Council Agenda Report

Item 6b

SUBJECT: REVIEW OF A 192-UNIT MIXED-USE DEVELOPMENT PROJECT INCLUDING 7 LIVE/WORK UNITS, A 585 SQUARE FOOT COMMERCIAL UNIT, ON-SITE PARKING, AND OTHER RESIDENTIAL COMMUNITY AMENITIES ON A 10.93-ACRE SITE LOCATED WITHIN THE 231-ACRE ORCUTT AREA SPECIFIC PLAN (3580/3584 BULLOCK LANE)

Figure 5. Proposed Tot Lot Location

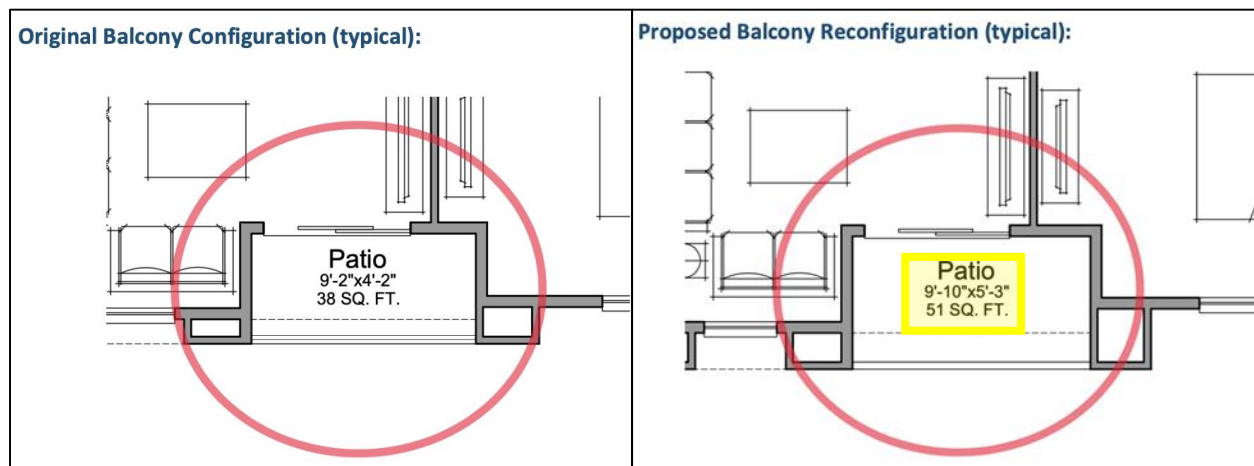
- Direct staff to work with the developer to add a family “tot lot” in an appropriate area; and
- Direct staff to work with the developer to explore the feasibility of deepening the 4-foot-deep balconies within the townhouse apartments.

Planning Commission Direction	Applicant/Staff Response
Add a family “tot lot” in an appropriate area.	<p>The applicant has identified a location for a tot lot in the eastern portion of the development on a small site that had previously been programmed to be passive open space with synthetic turf adjacent to the proposed Neighborhood Gathering Space (see Figure 5). The applicant has not proposed a specific design for the tot lot and is proposing that the builder of the Bungalows would design and build that facility.</p> <p><u>Staff Analysis:</u> Staff supports the proposed location of the tot lot, as it is adjacent to the Neighborhood Gathering Space that includes an outdoor kitchen, seating, and shade structure. The tot lot area is easily accessible and adjacent to a pedestrian walkway along Sponza Place. The size of the lot would be a minimum of 650 square feet, which is large enough to be functional and include small play equipment, especially in the context of being adjacent to the Neighborhood Gathering Space described above. As noted above, the applicant is not proposing to design this facility, nor identify any specific play equipment at this time. For that reason, staff is recommending Condition of Approval #34 be included in the Resolution to establish design parameters when this facility is built: <i>“Building plans for the project shall include a tot lot located adjacent and east of the Neighborhood Gathering Space identified on Sheet L1 of the project plans that is a minimum of 650 square feet in size and includes play equipment</i></p>

At the recommendation of the Planning Commission, a tot lot is now proposed in the eastern portion of the project, north of Sponza Lane, between Court 7 and Court 9, adjacent to the proposed Neighborhood Gathering Space (see discussion below in Table 1).
